PROJECT DESCRIPTION: Upgrade Staff Parking & Utilities Construction 585-17-110 at the Oscar G. Johnson VA Medical Center, Iron Mountain, MI
PROJECT NUMBER: 585-17-110
SOLICITATION NUMBER: 36C25218B0656

Pre-Bid RFI / Questions and Answers

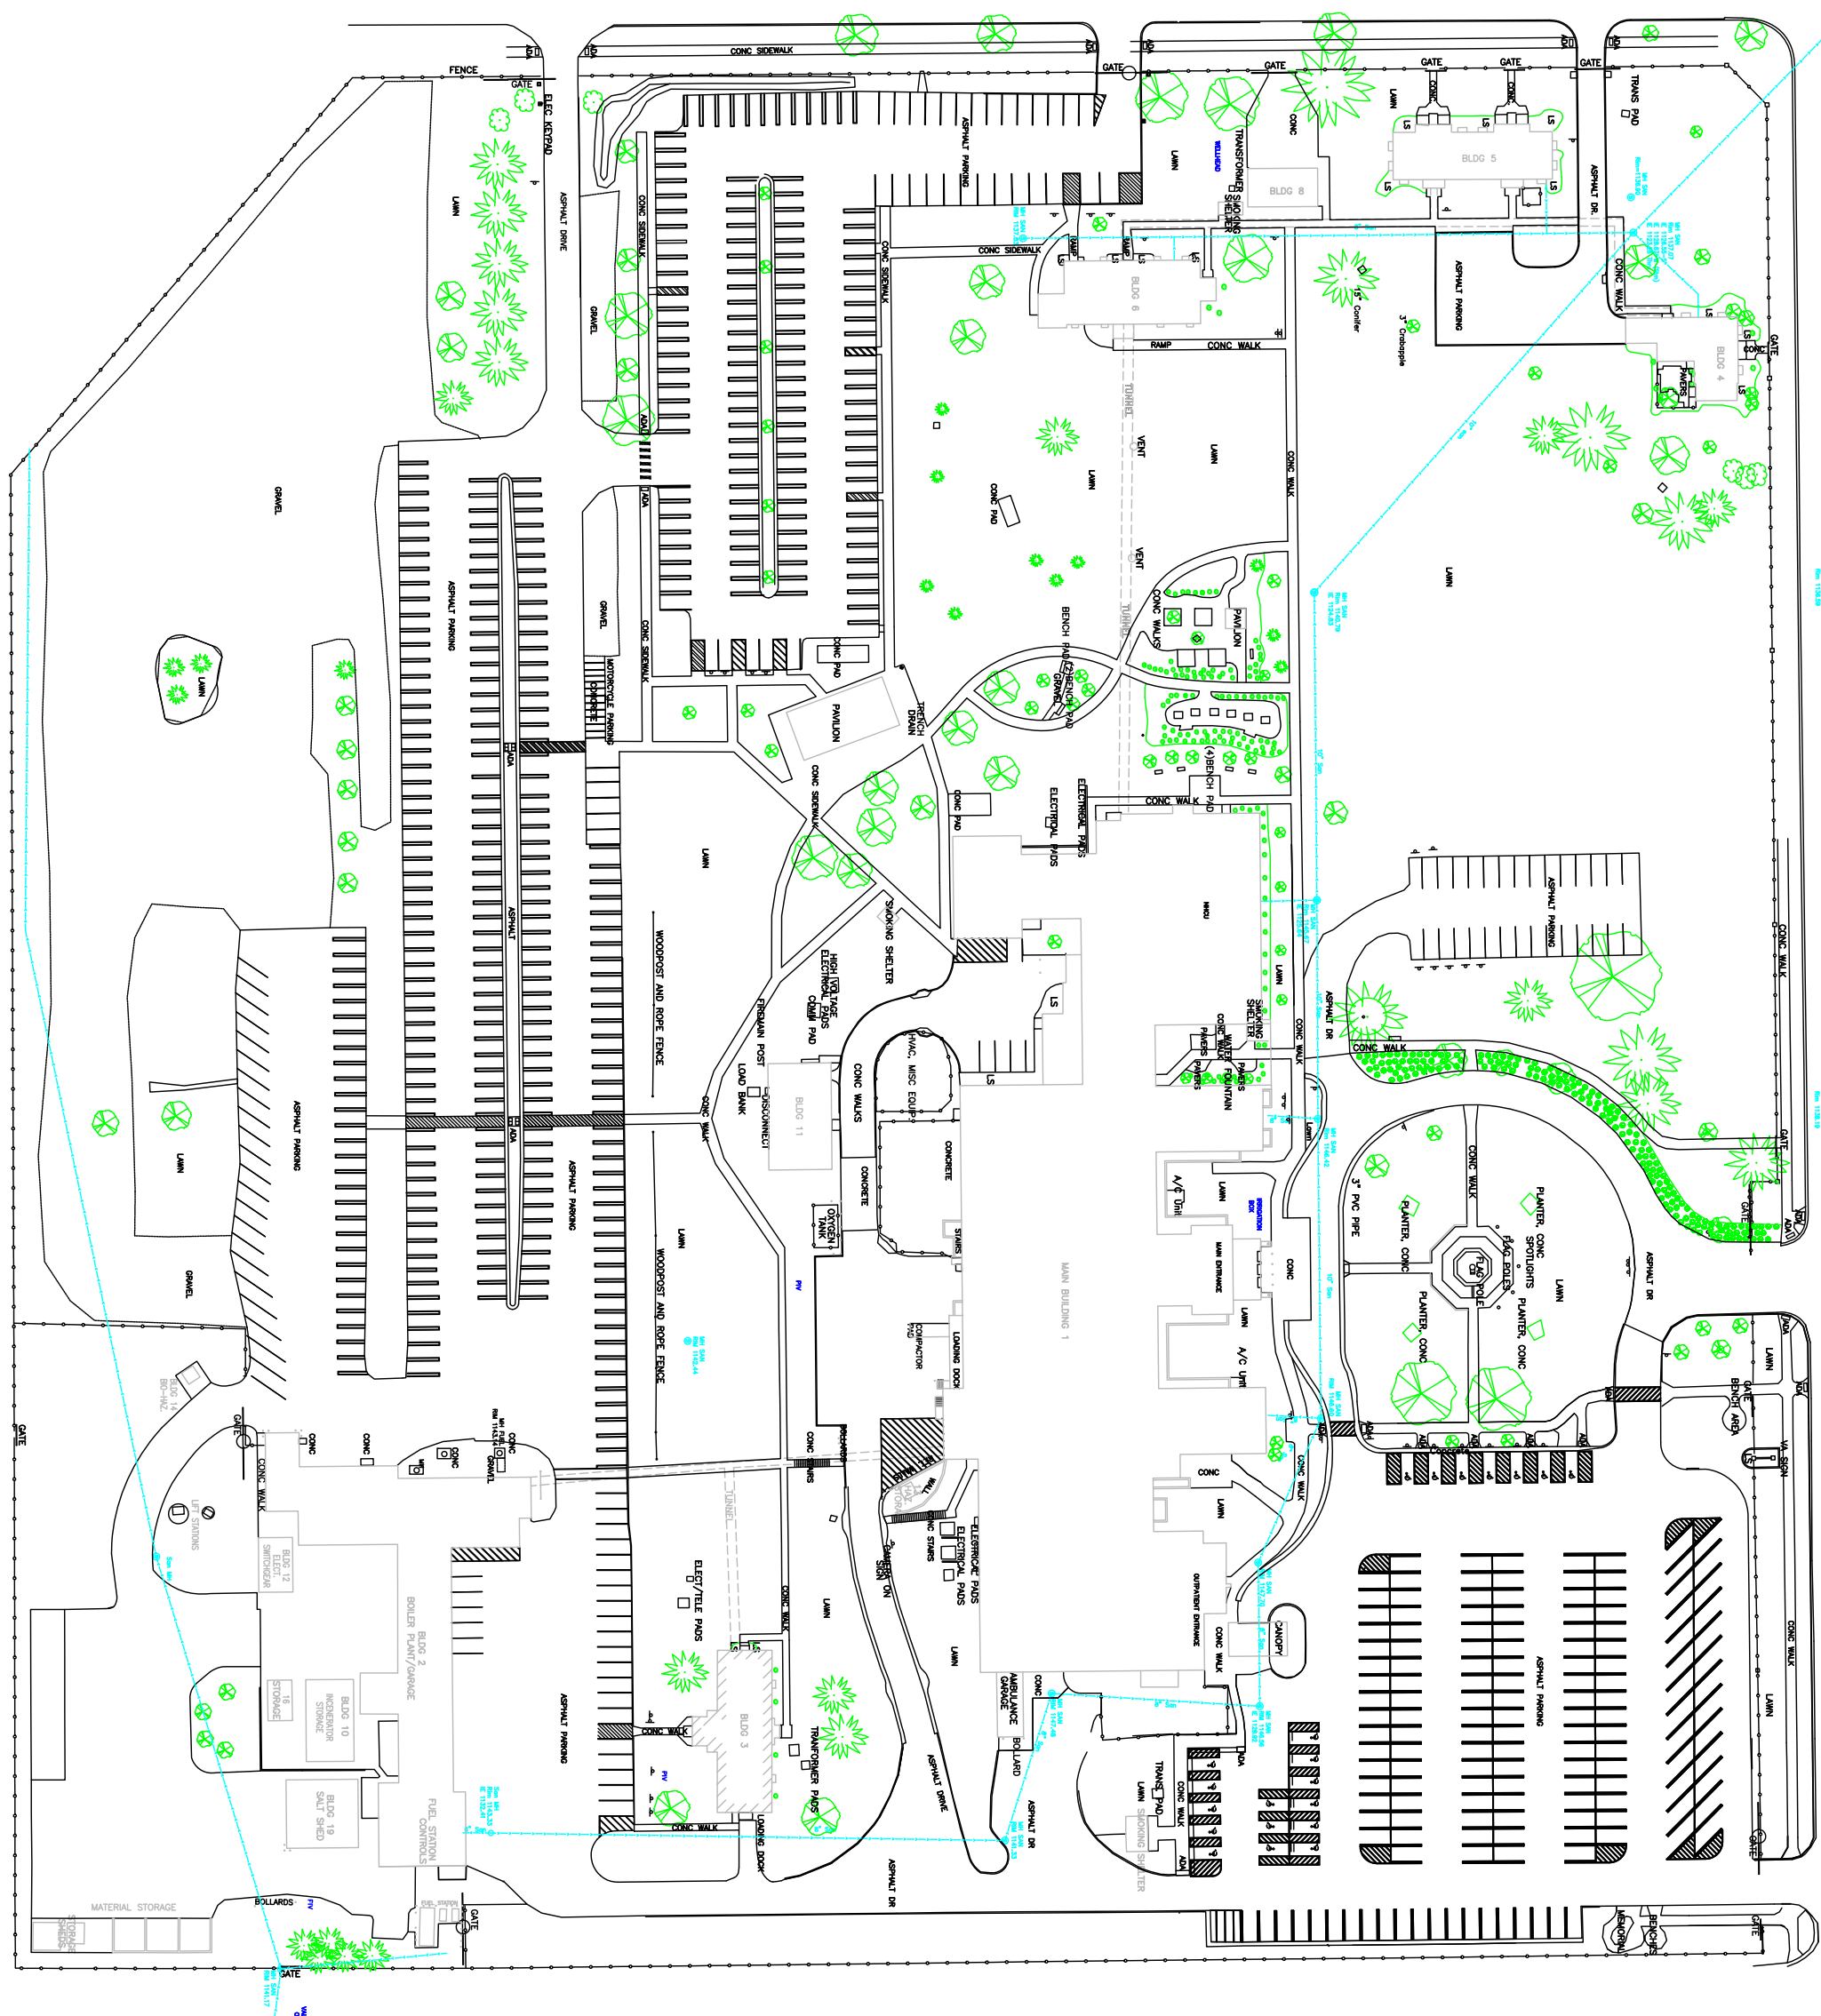
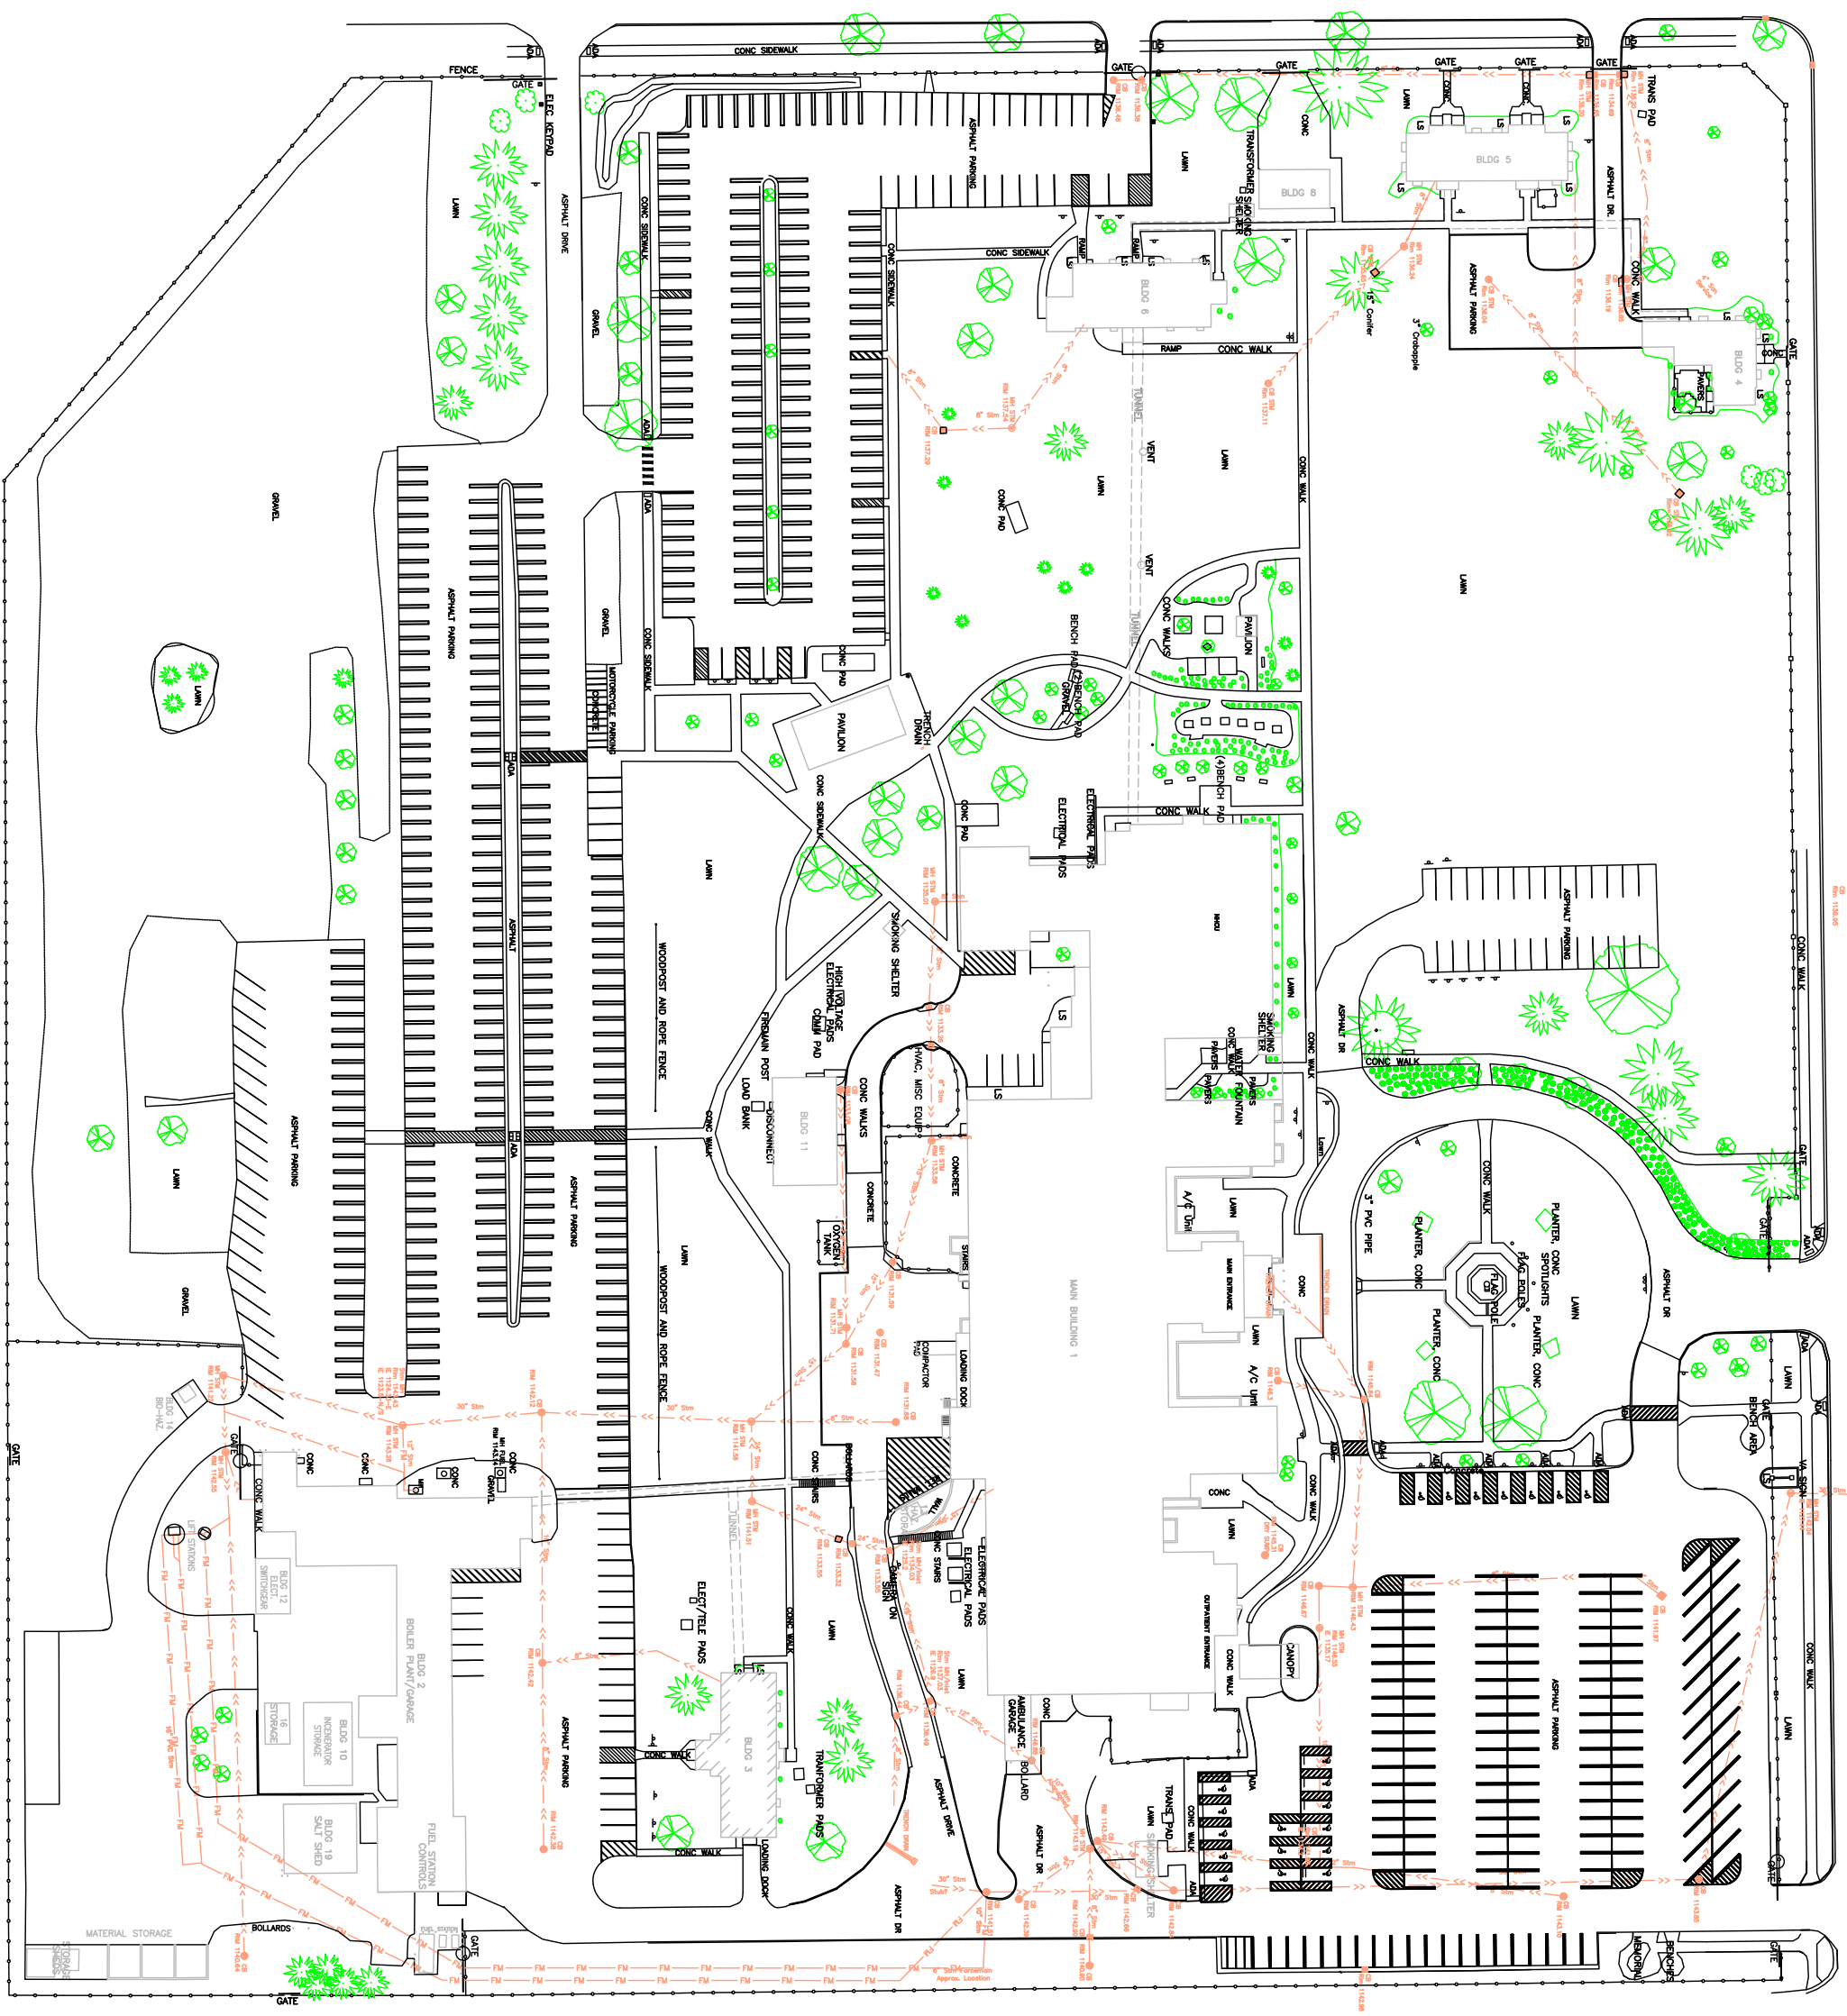
Q. Ref C-1; Is there an existing electrical feeder duct bank running from the south neighboring property transformers to the back of the hospital facility? If so can further information be provided?

A. The transformers on the south property line are no longer there. The existing ductbank has been removed in past construction projects. Existing drawings for utilities have been attached to this document and are for reference only. Contractor is responsible to contact MISSDIG prior to excavating. VA will locate and mark all known private utilities prior to excavation. Contractor required to give VA 2-week notice for this.
